Notice of Intent

Type of Action: APD Change

Procedure Description: XTO respectfully requests approval to make the below listed changes to the approved APDs. 1. Casing design to be changed from the “4-String Design – Engineered Weak Point” (FIGURE F) to the “4-String Design – Open 1st INT x 2nd INT Annulus” (FIGURE D). An open annulus will be utilized and monitored during completions operations. Post completion, bradenhead squeeze will be performed to tie back the 1st intermediate x 2nd intermediate annulus. TOC will be placed into the 1st intermediate shoe but still below the base of Potash interval. 2. No changes to the cementing, casing or mud circulating system designs will be required for the requested change. 3. There is no new surface disturbance. Please refer to the R-111-Q well bore diagrams in the attachment reflecting the changes requested. WELL NAME API Number JRU Apache Federal Com 114H 30-015-55830 JRU Apache Federal Com 115H 30-015-55831 JRU Apache Federal Com 804H 30-015-55853 JRU Apache Federal Com 904H 30-015-55858 JRU Apache Federal Com 709H 30-015-56190 There is no new surface disturbance.

JRU Apache Federal Com 114H 30-015-55830

Previous Design: 4-String Design – Engineered Weak Point**[Figure F] 4 String – 2nd Intermediate casing engineered weak point**

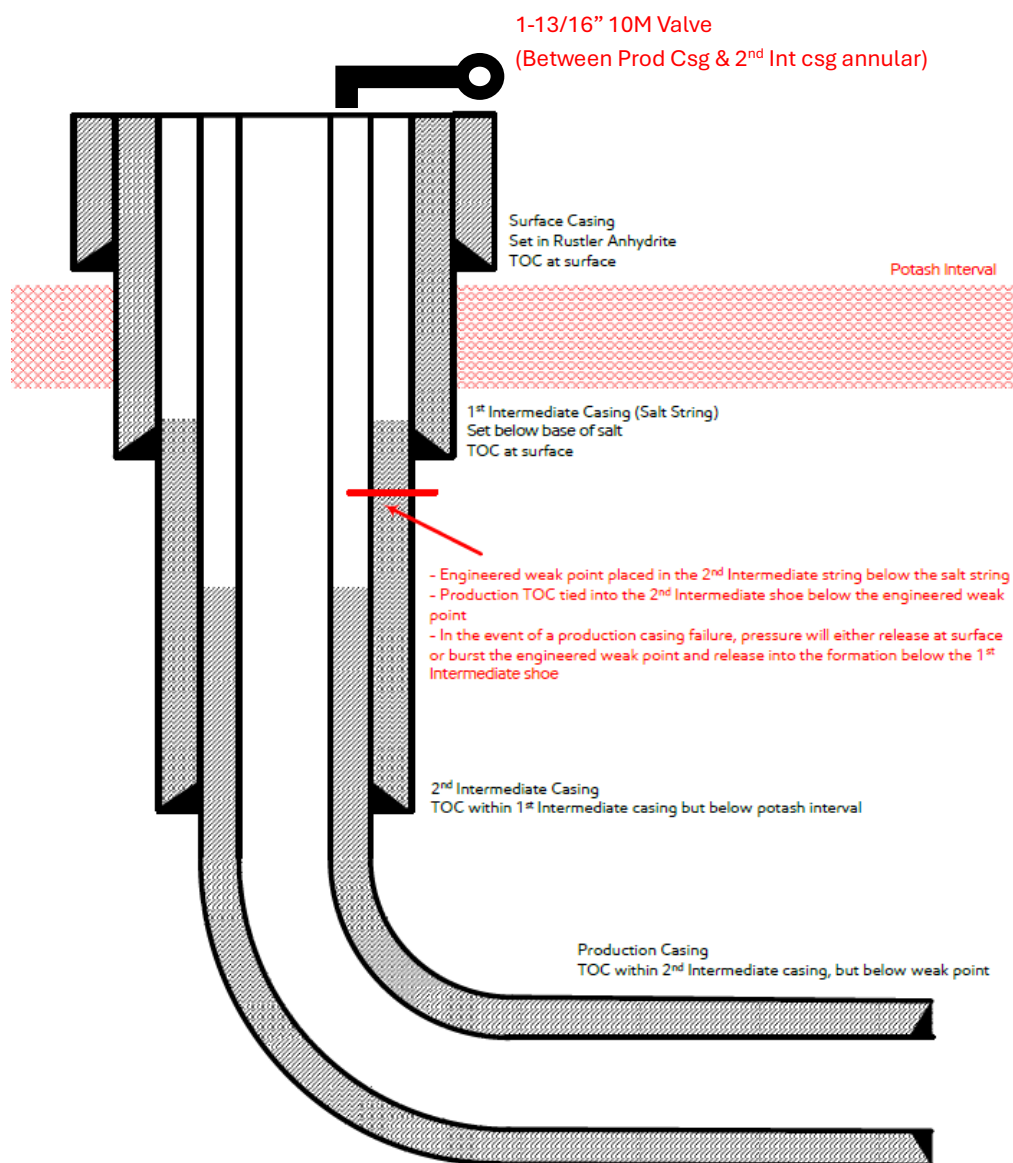
1. Casing design to be changed from the 4-String Design Engineered Weak Point (FIGURE F) to the 4-String Design Open 1st INT x 2nd INT Annulus (FIGURE D). An open annulus will be utilized and monitored during completions operations.

1. Casing design to be changed from the "4-String Design – Engineered Weak Point" (FIGURE F) to the "4-String Design – Open 1st INT x 2nd INT Annulus" (FIGURE D). An open annulus will be utilized and monitored during completions operations.

- 1) Alignment with KPLA requirements per schematic per schematic below, with engineering weak point casing design and utilizing new casing that meets API standards.
- 2) Contingency plans in place to divert fluids away from salt interval in event of production casing failure.
- 3) Intermediate 2 casing will consist of a primary cement job with TOC at the top of the Brushy Canyon formation within the Delaware Mountain Group.
 - a. Bradenhead squeeze to be completed after primary cement job to tie back TOC to intermediate 1 "Salt string" at least 500' but with top below Marker Bed 126 "Potash Interval".
- 4) Production cement to be tied back no less than 500' inside previous casing shoe (intermediate 2 casing) and below the engineered weak point.

[Figure D] 4 String – Uncemented annulus between 1st and 2nd intermediate casing strings

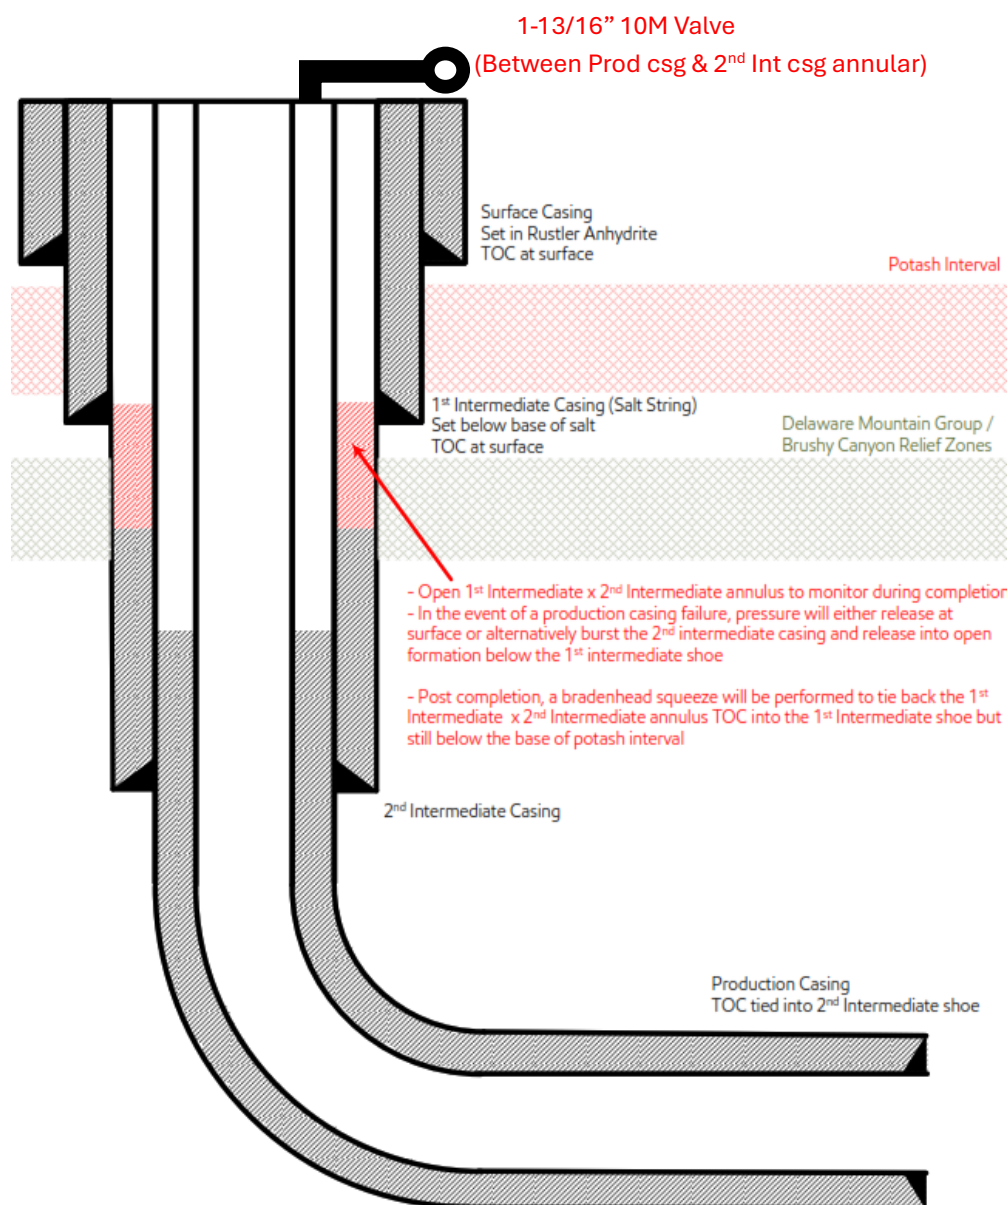
Post completion, bradenhead squeeze will be performed to tie back the 1st intermediate x 2nd intermediate annulus. TOC will be placed into the 1st intermediate shoe but still below the base of Potash interval.

New Proposed Design: 4 – String Design – Open 1st Int X 2nd Int Annulus (ICP 2 below relief zone)

- 1) Alignment with KPLA requirements per schematic above, leaving open annulus open for pressure monitoring during frac and utilizing new casing that meets API standards.
- 2) Contingency plans in place to divert fluids away from salt interval in event of production casing failure.
- 3) Intermediate 2 bradenhead squeeze to be completed within 180 days to tieback TOC to salt string at least 500ft but with top below Marker Bed 126.
- 4) Production cement to be tied back no less than 500ft inside previous casing shoe.
